Issue date / 発行日: 2021/3/31

Process Change Notice		Hirose Electric Co., Ltd. Koriyama plant Quality control section ヒロセ電機株式会社 郡山工場 品質管理課															
		Approval				Review				Creation							
		塚本 Tsukamoto				稲垣 Inagaki				野内 Nouchi							
<p>We truly appreciate your significant support always. We are currently planning on the below process change for the products planned to be delivered to your company. Forwarding shares the notification of the process change. Your approval on the change will be appreciated.</p> <p>貴社益々ご清栄のこととお喜び申し上げます。 日頃は弊社製品のお引き立てを賜り、厚く御礼申し上げます。 早速ですが、貴社への納入製品について、下記の通り工程変更を計画しております。 つきましては、本書にて工程変更のご案内をさせていただきますので、変更に際してのご承認を賜りたくお願い申し上げます。</p>																	
Customer's product number / 貴社品番				Product number by Hirose / 弊社品番				Product name by Hirose / 弊社品名									
				609-0019-5 609-0032-3				DM3C-SF DM3CS-SF									
Content of change / 変更内容	Type 区分	① Addition of contact plating company ② Addition of sealing treatment solution due to addition of plating company ③ Elimination of gold plating for the parts not designated in the drawing of the contacts

Issue No. / 発行№: PC-0009887(3)

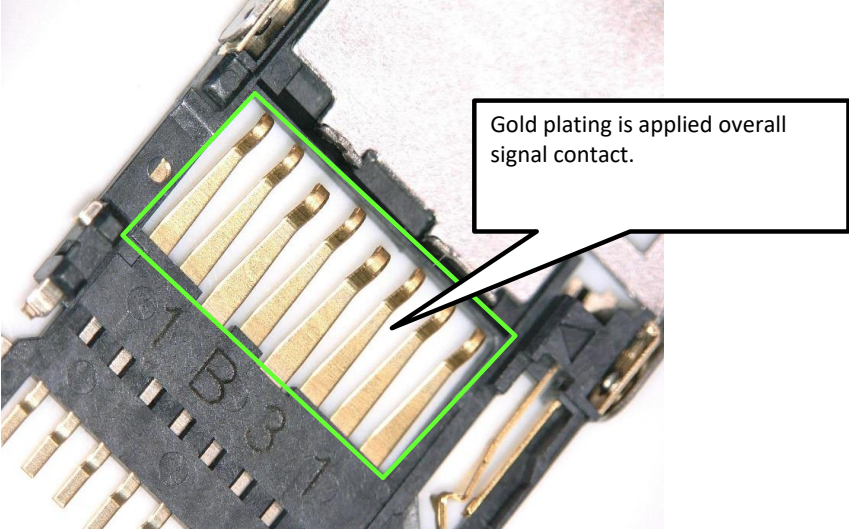
(1) T plating company only (2) Sealing treatment solution "TD5900" is used. (3) Application area of gold-plating is overall contact. (refer to attachment sheet)				(1) Plating company: In addition to Company T, Company F will be added. (2) For the sealing treatment solution, in addition to Company T's "TD5900", Company F's "CT-3" will be added. (It differs by the plating company.) (3) The gold-plated area of the contact is only at the contacting part. (Refer to the attachment sheet) Except for the contacting part, it will only be the base Ni plating.				The change will not affect performance as it is not related to design change. Necessary evaluation test will be conducted.							
Execution schedule of the change plan / 変更実施計画	Schedule 日程	1/F	1/E	2/F	2/E	3/F	3/E	4/F	4/E	5/F	5/E	6/F	6/E	7/F	7/E	8/F	8/E
	Preparation of process 工程整備	→															
	Preparation of standards, etc. 標準類の整備	→
